Technical Bulletin	Model 924S, 944, 944S, 944 Turbo	Group 1
	Subject: Oil Cooler/Oil Pressure Relief Valve Repair Guide	Part Identifier 1726/1740

Number
8904

Figure 1

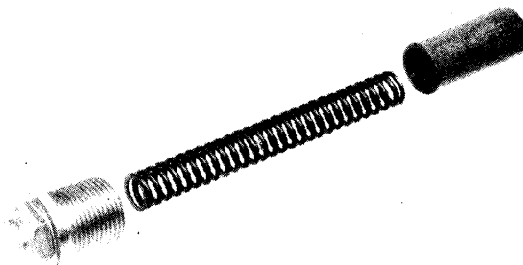
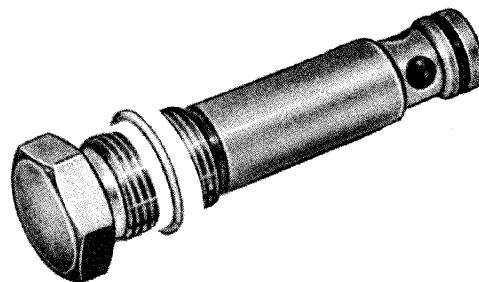
From start of production 1983, 944 cars came equipped with a spring and piston oil pressure relief valve (figure 1). This was used in all 944 and 944 Turbo up to the end of 1986 production. Also early 1987 924S used this system. In 1987 production of 944, 944S and 944 Turbo, a new type one-piece oil pressure relief valve PN 944 107 035 01 was installed (figure 2). Later production 1987 924S also received this valve. At around the same time a new type one-piece pressure relief valve, PN 944 107 035 11 was introduced as a retrofit to repair earlier engines from 1983 to 1986 along with the early 924S. With this, the old type spring and piston was discontinued as a spare part.

**Up to and including 1986 Model Year original equipment.
Three piece oil pressure relief valve.**

**From July 1986 (1987 Model year).
One piece oil pressure relief valve.**

Fig. A

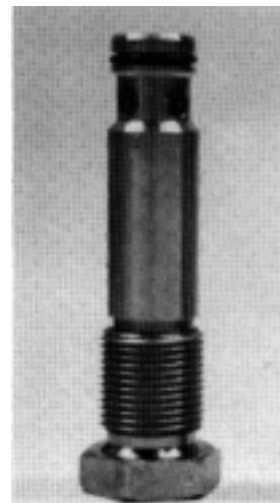
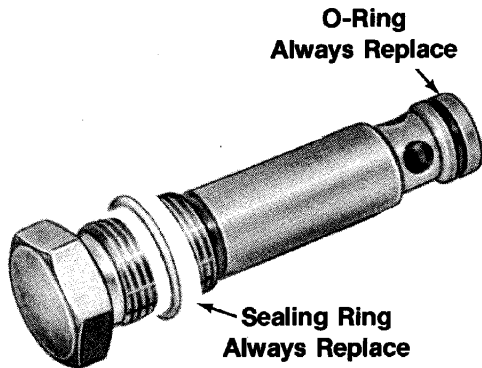
YEAR	MODEL(S)	QUALIFIER	VALVE TYPE
1987	924S	Up to engine # 43 H 01919-std. trans. 43 H 60384-auto. trans.	Fig. A
1987	924S	From engine # 43 H 01920-std. trans. 43 H 60385-auto. trans.	Fig. B
1983-86	944, 944 Turbo	All	Fig. A
1987	944, 944S 944 Turbo	All	Fig. B

Figure A Valve

- 1. Valve 944 107 035 11
- 2. O-Ring 944 107 935 11
- 3. Seal Ring N 043 815 3

Figure B Valve

- 1. Valve 944 107 035 01
- 2. O-Ring 944 107 935 01
- 3. Seal Ring N 043 815 3

Figure 1

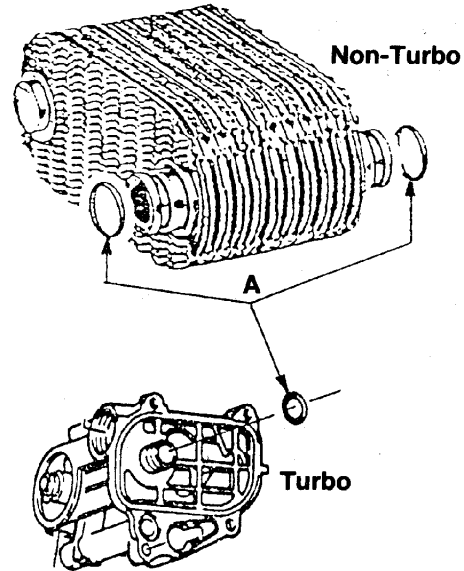
To determine if the oil cooler housing is the latest version, and to help prevent needless housing replacement, inspect as shown.

A - original design
B - new design

The sealing O-rings (A, figure 1) located on the oil cooler of normally aspirated cars and on the connecting pipe of the oil thermostat housing of Turbo cars, have been changed. The new version O-ring is now green in color (formerly red). When repairing, use **ONLY** the new version green O-rings PN 999 707 043 40.

Please note that the O-ring "A" in Fig. 1, is also installed in 944 Turbo cars. There are two O-rings on a short connecting pipe in the same place as they are found on normally aspirated cars.
